Bulletin #	SR - 5H - 903
Release Date	March 26, 1999
Effective Date	March 26, 1999
Supersedes	
Completion Date	June 30, 1999
Page	1 of 2

# SAFETY ALERT

Ride Manufacturer	Frank Hrubetz & Co., Inc. Killinski Mfg. Company Man-Co Mfg., Inc.	Affected Production Dates	1973 until 1991
Ride Name	Hurricane	Affected Serial #'s	All
Model Number	All

Product: Hurricane

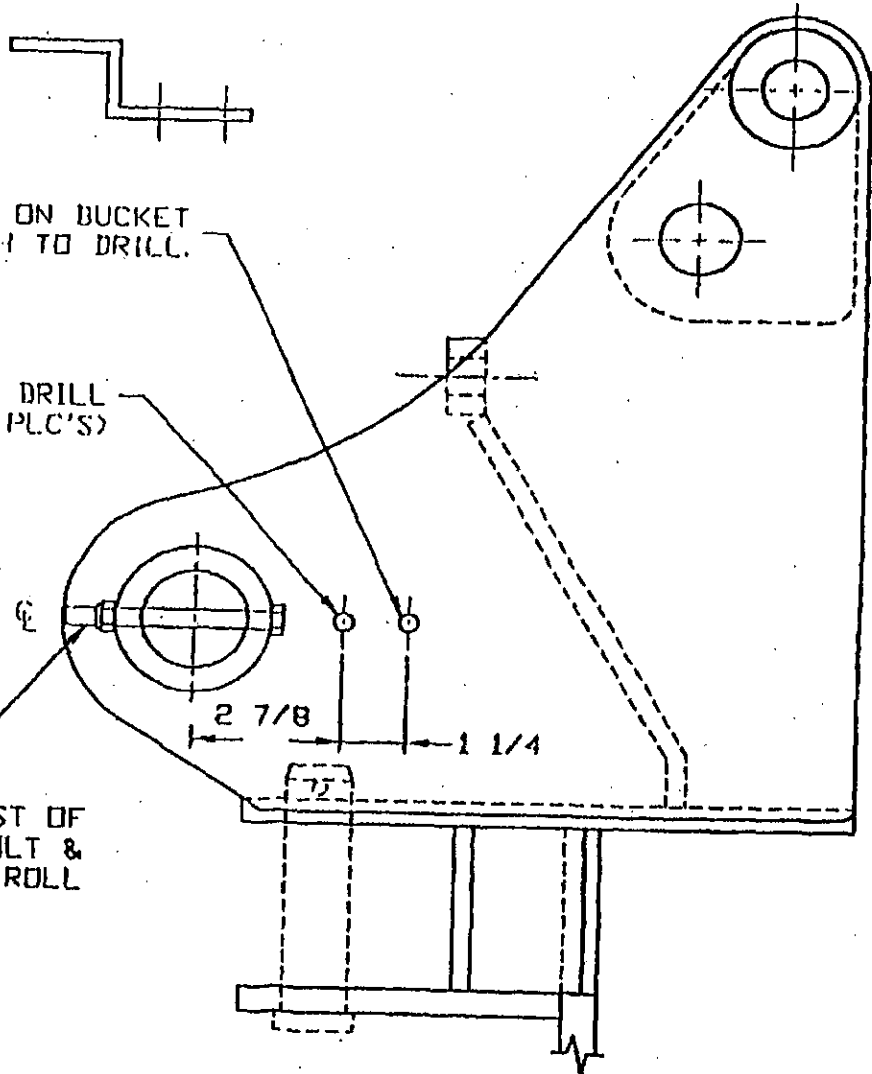
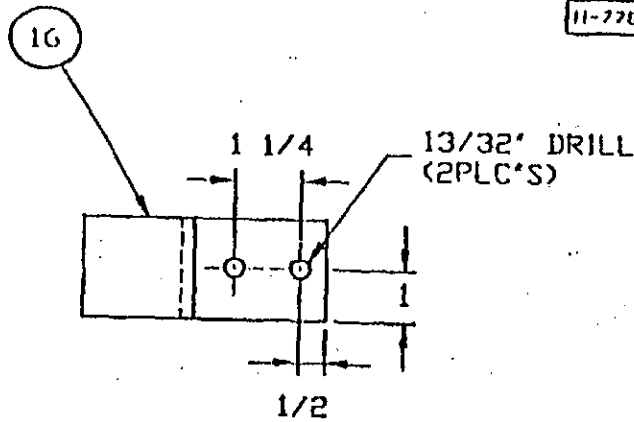
Page 2 shows the pin retainers that must be bolted to both sides of the car buckets that are attached to the end of the sweeps on all Hurricanes. With the pin retainers in place the shaft will be retained in position in the sweep even without the proper functioning of the pin locating bolt. Using an electric drill, drill one hole in both sides of the sweep bucket. The location of these holes is shown in Page 2 at 2 7/8". Bolt the pin retainer on with one bolt so that the tab of the retainer covers the end of the bucket pin. Now use the retainer as a jig to drill through for the lineup of the second 3/8 hole. Bolt the retainer in place using grade 8 bolts, grade 8 nyloc nuts and flat washers as called out in the material list on page 2. Insert the bolt from the inside to the outside of the bucket. Place the nyloc nut on the outside face of the bucket so it can be easily inspected. Torque to 40 ft. lbs. The flat washers are located under the bolt head and under the Nyloc nut.

POSITION ITEM 16 ON BUCKET  
& CENTER PUNCH TO DRILL.

13/32 DRILL  
(2 PLC'S)

ITEM #20 CONSIST OF  
3/8 GRADE 8 BOLT &  
NYLOCK NUT OR ROLL  
PIN.

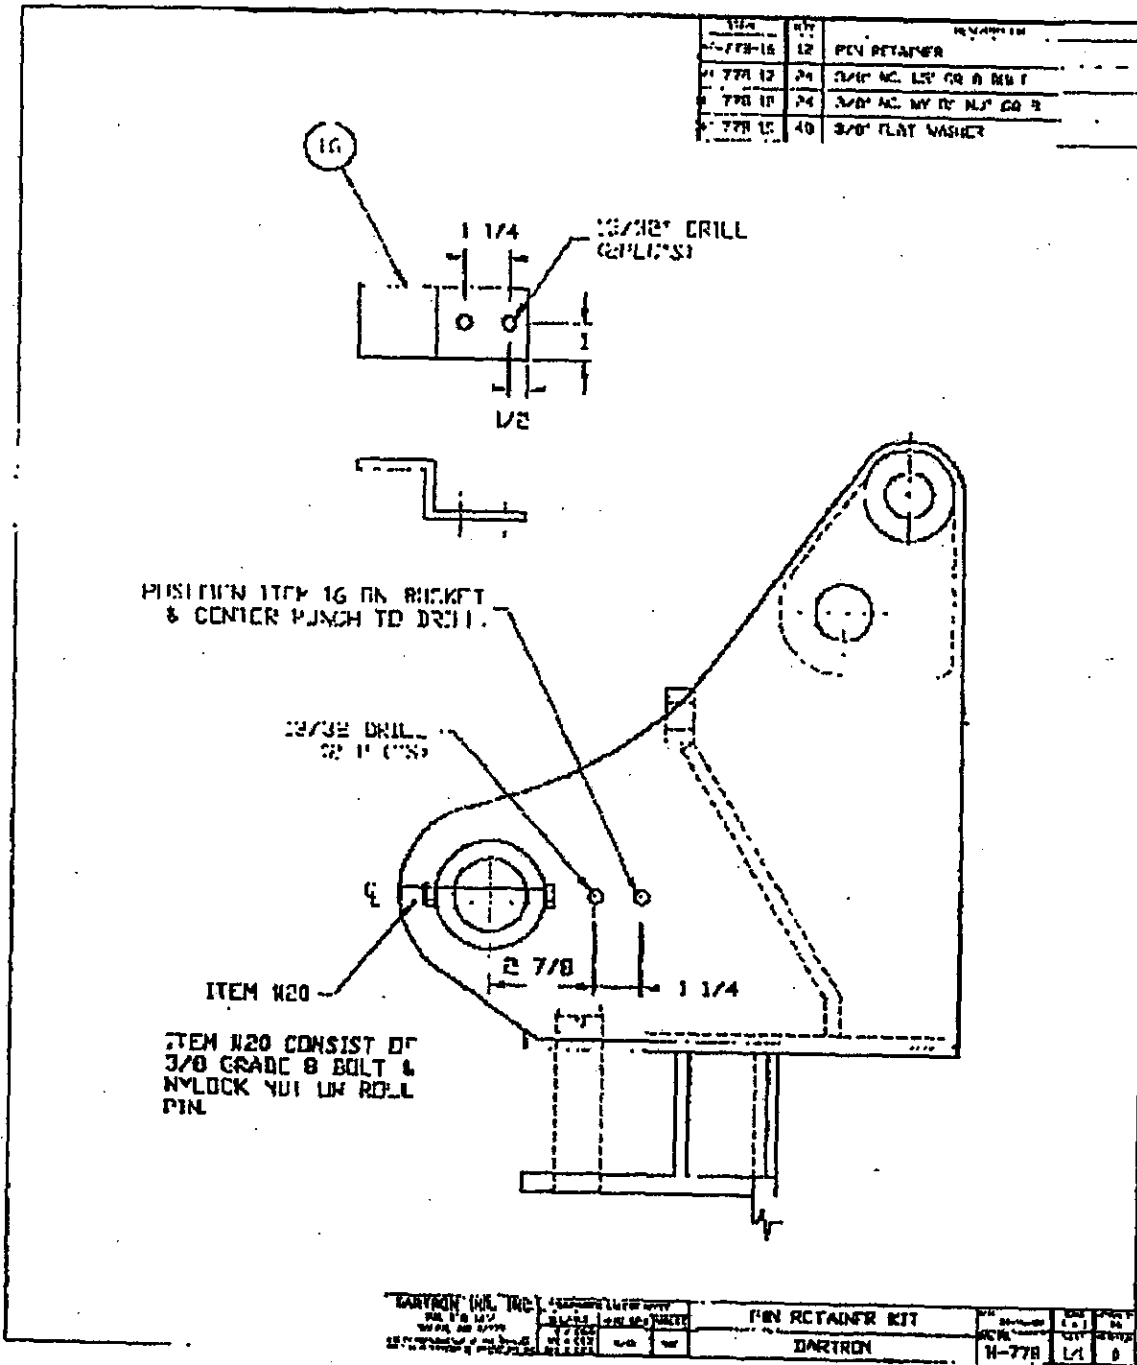
Before implementing changes explained below remove the cars from the sweeps. Find the grease zerk on the end of the sweep. Add lubrication to this zerk until the cavity is full. Inspect the bolt or roll pin shown as item 20 on Attachment I. Be sure the bolt is a grade 8. Inspect to be sure that it is not damaged and capable of maintaining the pin in its bore and prohibits the pin from rotating. Replace with a 3/8 NC x 4" grade 8 bolt and grade B nyloc nut if any damage is found. Car bucket must also rotate freely in relation to the sweep, indicating that the bushings in the sweep end are not binding on the shaft. Keeper bolt orientation must also be as shown in Attachment I in order to clear the pin retainer.

Attachment I shows the pin retainers that must be bolted to both sides of the car buckets that are attached to the end of the sweeps on all Hurricanes. With the pin retainers in place the shaft will be retained in position in the sweep even without the proper functioning of the pin locating bolt. Using an electric drill, drill 1 hole in both sides of the sweep bucket. The location of these holes is shown in Attachment I at 2 7/8". Bolt the pin retainers on with one bolt so that the tab of the retainer covers the end of the bucket pin. Now use the retainer as a jig to drill through, for the lineup of the second 3/8 hole. Bolt the retainer in place using grade 8 bolts, grade 8 nyloc nuts and flat washers, as called out in the material list in Attachment I. Insert the bolt from the inside to the outside of the bucket. Place the nyloc nut on the outside face of the bucket so it can be easily inspected. Torque to 40 ft lbs. The flat washers are located under the bolt head and under the nyloc nut.

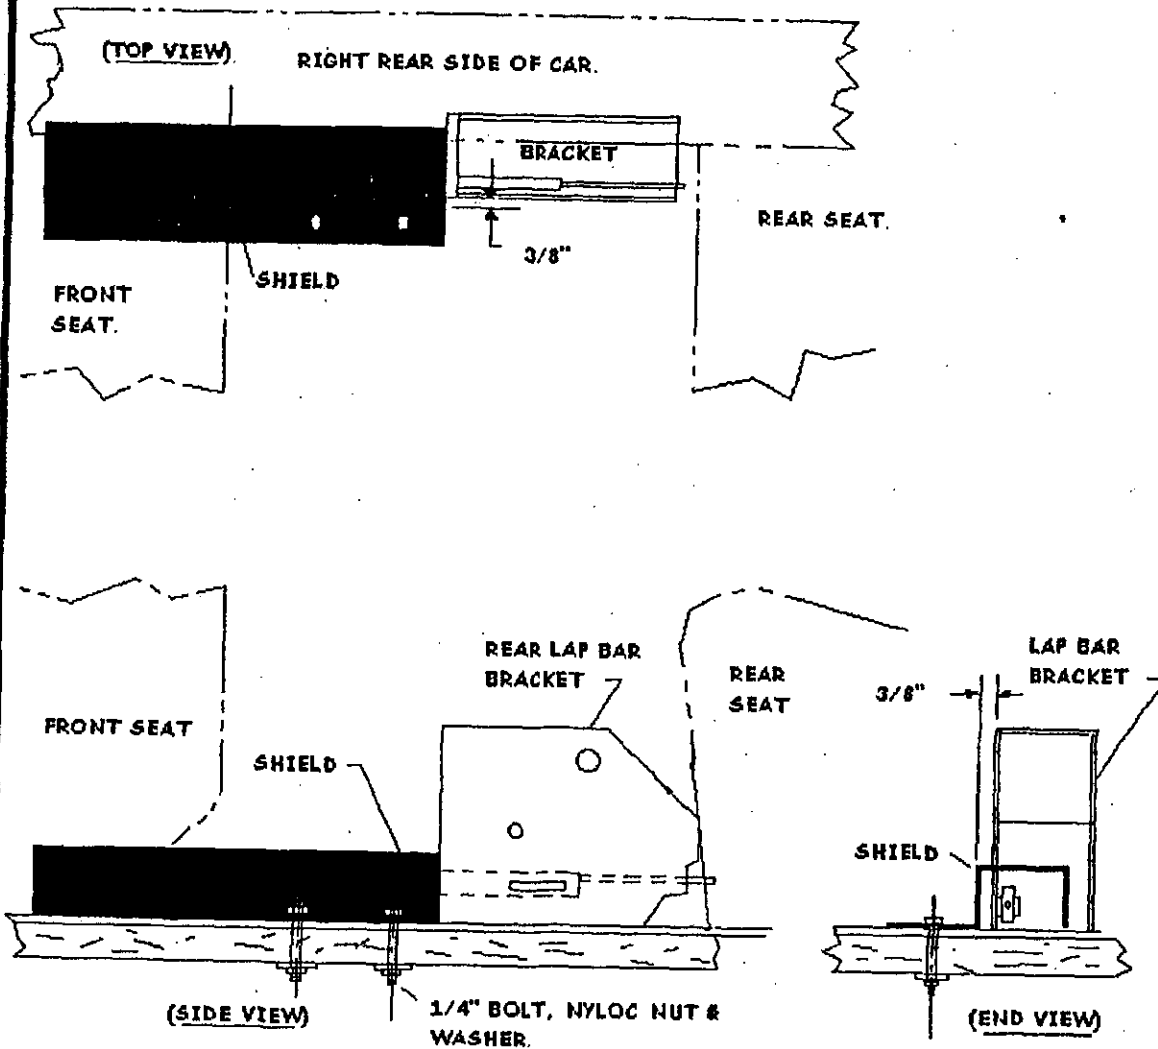
Using the holes in the shield flange as templates, drill 2 holes 17/64" dia. through the floor of the car. Install bolts, washers, and locking nuts as shown below. Tighten bolts to no more than 100 in lbs of torque. **CAUTION:** Do not over-tighten nuts. They should be snug and not dimple fiberglass. **(SEE ATTACHED DRAWINGS)**

POSITION THE SHIELD SO THAT IT IS AGAINST THE REAR LAP BAR BRACKET AND 3/8" OUT FROM THE FACE OF THE BRACKET. (AS SHOWN ABOVE)
